ACCESS COMPLIANCE ASSESSMENT REPORT

Building Code of Australia 2022 Amendment 1

PROJECT:	1A Truman Avenue, Riverwood
REF. No.:	NEW250435 (Rev 2)
DATE:	02/06/2025
CLIENT:	NSW Land and Housing Corporation
CONTACT:	c / Stephanie Hong
EMAIL:	stephanie@artmade.com.au
CONSULTANT:	Mauricio Vera
PHONE No:	0451 078 790
EMAIL	mvera@newcrown.com.au

Identified Principal Pedestrian Entrance

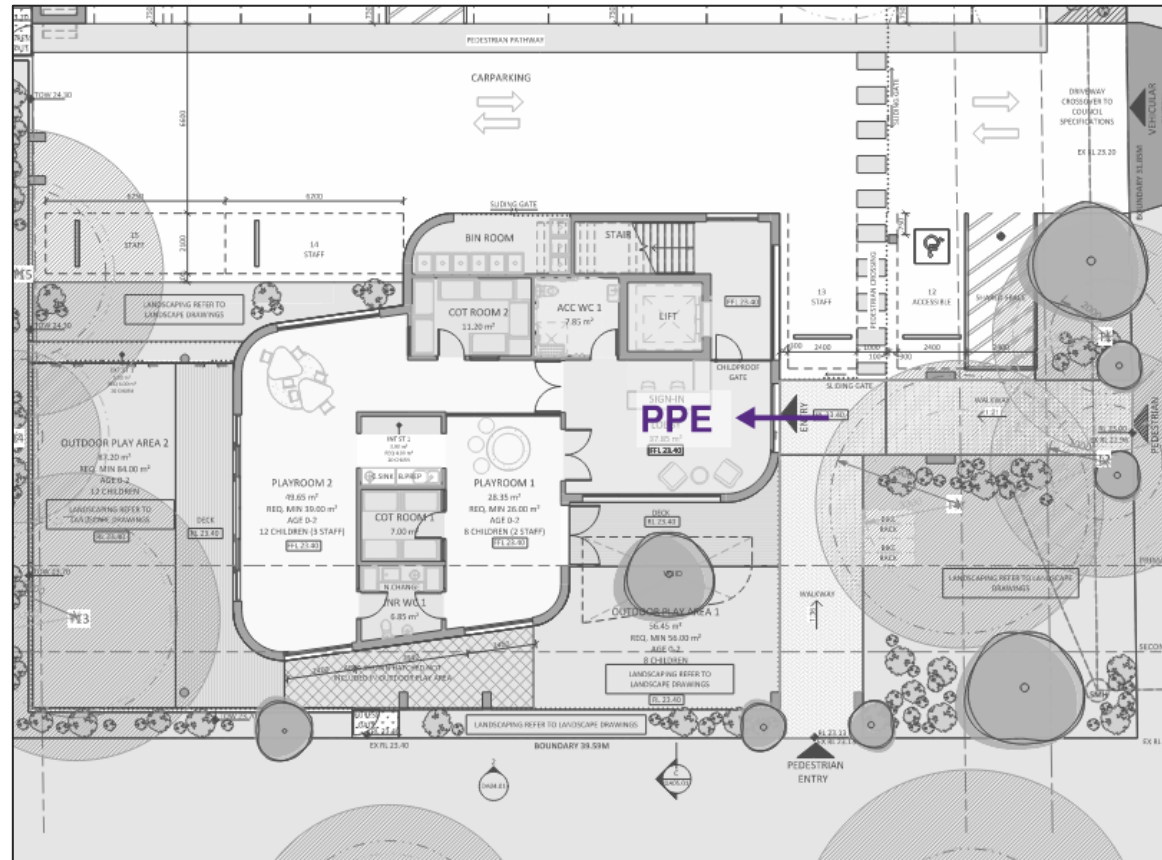
3. Principal Pedestrian Entrance (NCC D4D2, D4D3 & AS1428.1)		
CRA	<p>An accessible entry into the building is required as follows:</p> <ul style="list-style-type: none">- Through the principal pedestrian entrance (of the building or part)- Through 50% minimum of all pedestrian entrances (not including D4D5 exempt areas)- Non-accessible pedestrian entrances are to be located not further than 50m from the accessible one for building with 500m2 total floor area or more (not including D4D5 exempt areas).- Accessible pedestrian entrance provided with multiple doorways:<ul style="list-style-type: none">• Not less than 1 is to be accessible (if not more than 3 doorways provided)• Not less than 50% are to be accessible (if more than 3 doorways provided). <p>Note: Best practice is to design all doorways accessible to avoid confusion and additional accessible signage.</p> <ul style="list-style-type: none">- Accessible entrances are to have a clear circulation space on both sides of doorways. This must be level and include 850mm minimum clear door opening, compliant with AS1428.1.- Door controls are to be in compliance with AS1428.1.	<p>Design aligns with DTS provisions. Compliance is achievable, subject to specialist confirmation where necessary.</p> <p>The principal pedestrian entrance serving the building is located on Truman Avenue (Lobby) and provided with a power operated door and subsequently achieving sufficient circulation spaces on both sides as per AS1428.1 Clause 13.3.4, in compliance with this clause. Ensure door controls (push buttons) are provided in a compliance location as per AS1428.1 Clause 13.5.</p>
